State of California  
AIR RESOURCES BOARD

**Final Statement of Reasons for Rulemaking,  
Including Summary of Comments and Agency Response**

ADOPTION OF THE REGULATION TO REDUCE GREENHOUSE GAS EMISSIONS  
FROM HEAVY-DUTY VEHICLES

Figure 4: Fuel consumption rates to overcome the aerodynamic drag for a typical Class 8 tractor traveling on a level highway as a function of speed, with various aerodynamic drag coefficients

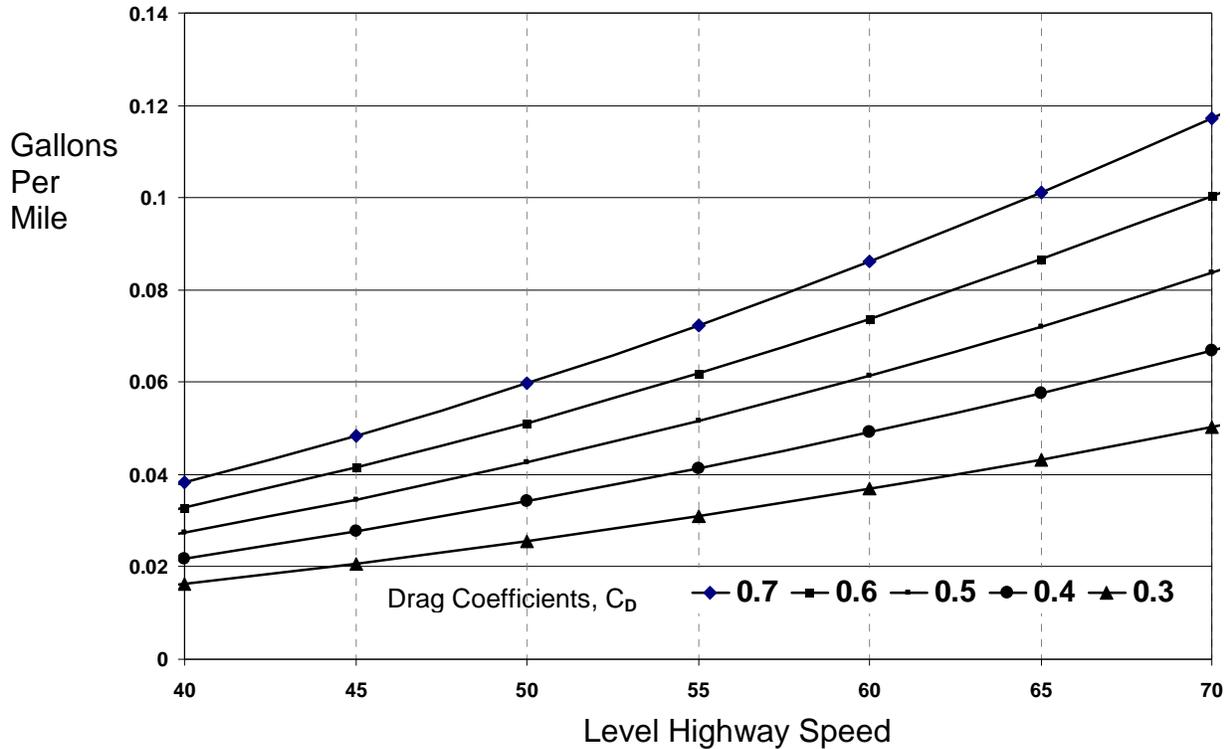
49. **Comment:** ARB has never conducted any studies on the proposed regulation regarding actual application. The numbers for a federal program are going to display different outcomes than a state whose truck speed limit is 55 MPH. All of the federal testing was performed at speeds of 62 MPH. This 7 MPH reduction could account for more fuel efficiency (and less greenhouse gas emission) than adding any aerodynamics to a trailer. (MCA)

**Agency Response:** ARB agrees with the commenter that the fuel efficiency improvement associated with the application of SmartWay verified aerodynamic technologies will be less for tractor-trailers operating at 55 mph than 62 mph. ARB also agrees that improvement in fuel economy associated with reducing vehicle speed from 62 mph to 55 mph may be greater than the improvement associated with adding aerodynamics. However significant improvements in fuel efficiency can be gained by improving aerodynamics even for vehicles that typically travel at 55 mph. This relationship is shown in Figure 4 below:

In Figure 4, the vertical axis presents the fuel consumed to overcome aerodynamic drag in gallons per mile travelled. Five estimates of fuel consumption are shown, corresponding to five values of aerodynamic drag coefficients ( $C_D$ ) between 0.7 and 0.3. A typical tractor-trailer has a  $C_D$  of around 0.6.

From the data illustrated in Figure 4, one can estimate the impact of aerodynamics at 55mph and compare it to the impact of lowering the speed from 62 to 55 mph. If a tractor trailer's  $C_D$  is reduced from 0.6 to 0.5 through the application of aerodynamic technologies, the amount of fuel saved from the reduction in aerodynamic drag would be about 10 gallons per thousand miles travelled at 55 mph. This 10 gallon per thousand miles travelled represents the fuel savings benefit of the regulation from the aerodynamic requirements only. Additional savings would be gained through the reduction in rolling resistance from the use of low rolling resistance tires.
